OBJECTION - LANDSCAPE AND VISUAL IMPACT

Planning Application: Land North of Taylors Farm

Application Reference: UTT/25/2786/OP

Takeley Street Action Group (TSAG)

PHOTOMONTAGE 1 – SCREENING VEGETATION SHOWN WILL BE REMOVED FOR THE PROPOSED FILTER LANE

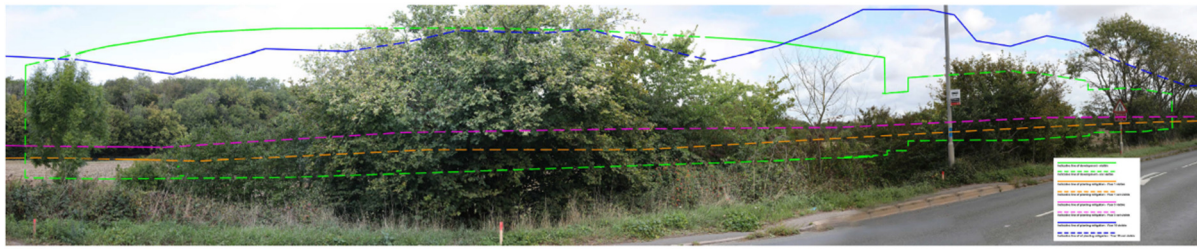
However, both the Year 1 and Year 15 visualisations are materially misleading. The vegetation shown screening the warehouses cannot remain in place because the proposed access road and filter lane are to be constructed through this area. As a result, the photomontages and the wireframes fail to accurately represent the development that is being proposed. The dashed

Green line “Indicative Line of Development – Not Visible” is incorrect. The reality is that the warehouse will be visible in it’s entirety from this viewpoint.

In the "Year 1 Visualisation" shown above, the existing vegetation provides a substantial amount of screening between the road and the proposed warehouses. However, as demonstrated above, this area of vegetation will need to be removed to accommodate the proposed filter lane and access works. The photomontage therefore relies upon screening that will no longer exist once the development is constructed.

Furthermore, the small single-lane turning shown within the visualisation is not representative of the junction proposed by the applicant. The main access and filter lane are to be constructed further along the road and occupy a significantly larger area than is depicted in the photomontage. As a result, the visualisation understates both the extent of vegetation loss and the visibility of the proposed warehouse development.
